<b>Project Name &amp; Applicant Team:</b> Project Name: 1333 Alabama Avenue, SE Applicant: Sq5914 llc CityPartners Geoffrey H. Griffis, Managing Partner 1817 Adams Mill Road, NW Suite 200 Washington, DC 20009	
<b>Case Type &amp; No. (PUD, LTR, etc.)</b> PUD (case number not yet assigned)	
<b>Street Address:</b> 1333 Alabama Avenue, SE; Washington, D.C.	
<b>Current Zoning and/or Overlay District:</b> R-5-A	
<b>Date of Filing:</b> We anticipate that the PUD application will be filed on or about April 25, 2013	
<b>Estimated Date of Hearing:</b> No hearing date has been designated yet.	
<b>Description of Project:</b> The subject site is located on Square 5194 in Ward 8 on the south side of Alabama Avenue, east of 13 <sup>th</sup> Street, and directly across the street from the Kiss 'n Ride lot for the Congress Heights Metro Station. The site is located within the R-5-A zoning district and currently is occupied with four existing residential buildings and Congress Heights Metro Station service plaza. The Applicant proposes to redevelop the site with a mixed-use development that would contain approximately 205,274 square feet (SF) of office space, 212,177 SF of residential space (approxi

## Historical ADT Growth Rate

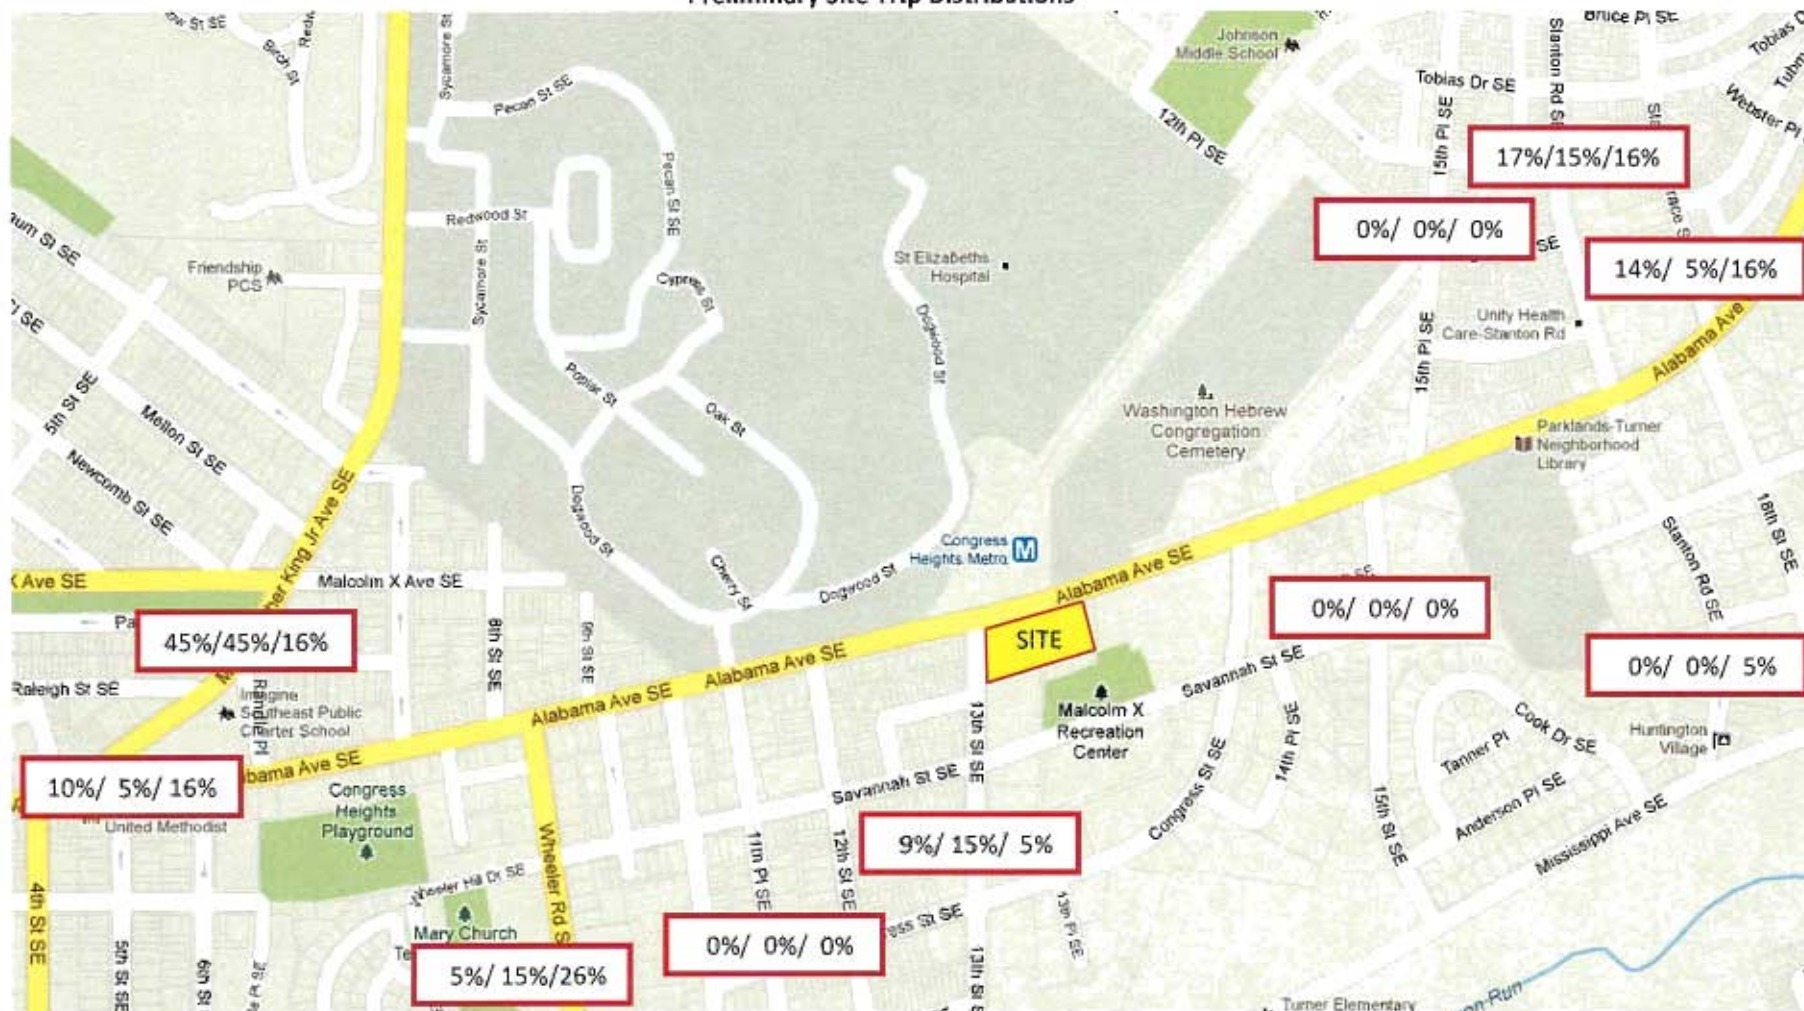
<p>to be conducted in three phases.</p> <ul style="list-style-type: none"> <li>• Phase 1A will deliver 1,179,550 gross SF, 4,400 employees, 690,550 gross SF of garage space and a 69,200 SF central utility plant in Summer 2013.</li> <li>• Phase 1B will deliver 193,650 Gross SF of amenity space in six adaptive reuse buildings and a total of 983 parking spaces.</li> <li>• Phase 2A will deliver 899,900 gross SF of new and renovated historic buildings by June 2014</li> <li>• Phase 2B will deliver 750,000 gross SF office headquarters at the east campus and include a total of 2260 parking spaces by June 2014.</li> <li>• Phase 3 will deliver the remaining office government agency tenants by June 2016 with 990 parking spaces.</li> </ul>	
<p><u>Background Growth</u></p> <p><b>Guidelines:</b> The study will account for annual growth or decrease in through traffic on minor and principal arterials that pass through the proposed study area. See Section 3.2.9 of the CTR guidelines.</p> <p><b>Proposed annual background growth:</b> Based on Historical ADT's from the DDOT website for the roadways nearby the subject site, it was determined that a growth rate less than 0.7% has been experienced for traffic volumes in the area. A conservative growth rate of 1.0% will be used for annual compounded background growth. The Historical ADT's have been provided in Attachment D.</p>
